We would like to thank the reviewers for the time and effort they dedicated to reviewing our manuscript. We greatly appreciate their insightful comments and valuable suggestions, which helped to improve the quality and clarity of our work. Below are our point-by-point responses to each of their comments (shown in red). Our replies and the corresponding changes made to the manuscript are highlighted in blue.

Response to the referee report # 1

The authors presented "CFD analysis of dynamic wind turbine airfoil characteristics in transonic flow using URANS". This study investigates the effects of aerodynamic performance for unsteady dynamic wind turbines airfoil on compressible and transonic flow condition. A URANS method is used to simulate flowfield of wind turbines airfoil. The findings are presented in manuscript, and the conclusions are supported by the results. The study falls within the scope of wind energy science. It is recommended that the manuscript be accepted after the following comments are addressed.

Figure 1: Sketch of a power curve (left), sketch of the angle of attack distribution for wind turbine airfoil (right-up), and operational conditions for IEA-15MW RWT tip airfoil from De Tavernier and von Terzi, 2022 (right-down)

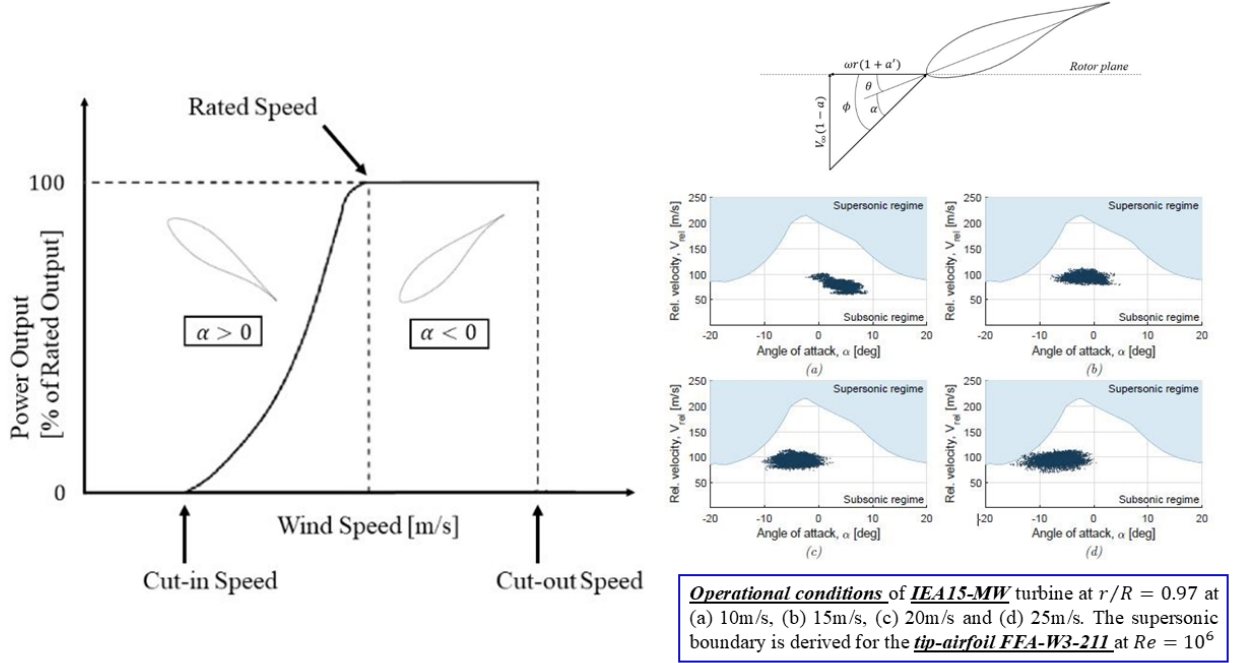
- **Comment 5:** In case setting, the authors simulate the range angle within negative angle of attack, if considering within positive angle of attack when the airfoil pitch condition.

Response: We understand that the reviewer is wondering how we chose the range of angles of attack. In the present study, we focused on negative angles of attack because they are the most representative of the actual operating conditions at the blade tip once the rated wind speed is reached, and they also correspond to the incidence range where transonic flow phenomena are likely to occur. The sketch of the power curve on the left of Figure 1 illustrates the typical control strategy of a modern wind turbine. A power curve represents the power output as a function of wind speed: it increases approximately cubically with wind speed up to the rated value, and then it is kept constant through pitch control. In the below-rated regime, the blades are pitched so that the airfoil sections operate at positive angles of attack, close to their aerodynamic optimum. This maximizes the lift-to-drag ratio of the blade sections, thereby enhancing the aerodynamic efficiency of the turbine blades, and enabling the turbine to capture the maximum available power from the incoming wind. In contrast, once the rated wind speed is reached, the pitch control progressively rotates the blades toward a lower angle of attack to reduce the aerodynamic loads and maintain constant power output. As a result, the local angle of attack along the blade sections is progressively reduced, depending on the combination of blade pitch, twist distribution, and local relative wind velocity. At the tip, pitching out the blades will result in negative angles of attack under above-rated conditions, as shown in Figure 1 (right-up). De Tavernier and von Terzi, 2022 considered the operational conditions along 97% of the

blade of the IEA-15MW RWT. Their analysis indicates that local Mach numbers exceeding one can occur at the blade tip close to the cut-out wind speed, highlighting the occurrence of transonic flow. In these operational conditions, the wind turbine tip airfoil is operating at a highly negative angle of attack. For these reasons, we restricted our investigation to negative angles of attack, representing the most relevant regime for the objectives of this study.
